This Service Information bulletin supersedes S.I. 34 03 99 dated December 1999. Please remove and discard S.I. 34 03 99 from your binder.

E46 Except four wheel drive and M3 up to 2/01 production.

Some E46s produced prior to 2/01 may exhibit a steering vibration when braking, which is usually most noticeable in the 60-50 MPH range.

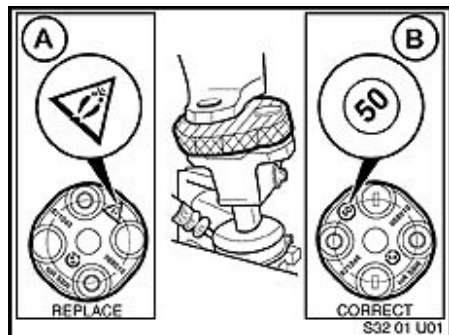
Check the supplier symbol on the flex coupling connecting the steering spindle to the steering rack.
Note: The symbol will only be found on one side of the rubber disc.
If the symbol found matches illustration A, the coupling must be replaced.
If the symbol found matches illustration B, the coupling is correct and does not have to be replaced.

If the flex coupling must be replaced, install part number 32 30 6 752 957 along with two new bolts part number 32 30 1 094 718, as per Repair Manual, section 32 31 053.

Original style lines (A)
Dampened lines (B) (must be removed)

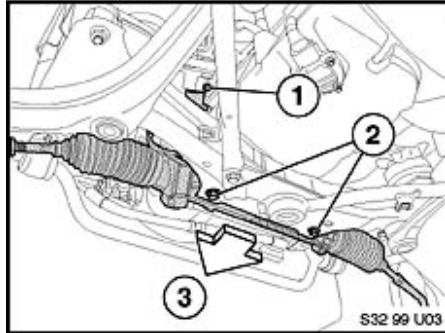
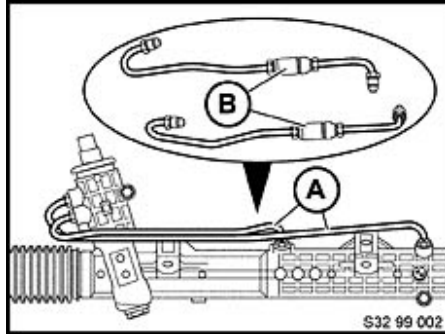
If the car previously had the dampened hydraulic lines (part number 32 13 6 750 847, item B in illustration below) installed on the steering rack they must be replaced with original lines. This portion of the repair should be performed in conjunction with the replacement of the steering coupling.

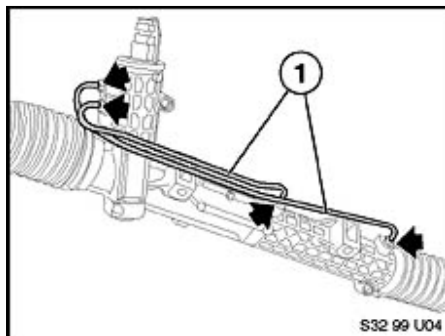
Clean any dirt from around fittings and remove dampened lines from rack.
Cars produced before 4/99 will require part number 32 13 1 096 636.
Cars produced 4/99 and later will require part number 31 13 1 096 845.

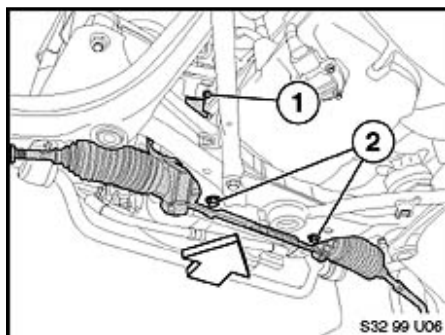
Lubricate O rings on original style lines (without dampers) with ATF, and install (1). Tighten fittings to 7.5Nm.

Reinstall rack bolts (2) with new nuts part number 31 35 1 095 452 and tighten to 42 Nm.
Connect rack to flexible coupling using a new bolt, part number 32 30 1 094 718, tighten to 22 Nm.

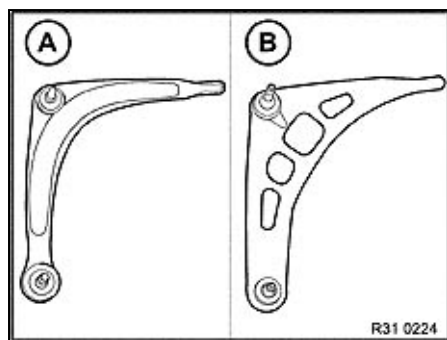
- Replace front brake discs and pads per Repair Manual section 34 11 220
- Balance the front wheel assemblies, including "matching" the tire to the rim where necessary. Refer to Repair Manual section 36 10 508 and 36 10 713.
- Replace the control arm (wishbone) bushings with the latest design per Repair Manual Section 31 12 049. The part number required depends on the type of control arm installed in the vehicle. Refer to the

illustration below to determine numbers required.

Type A: Use kit part number 31 12 6 757 622

Type B: Use kit part number 31 12 6 757 623
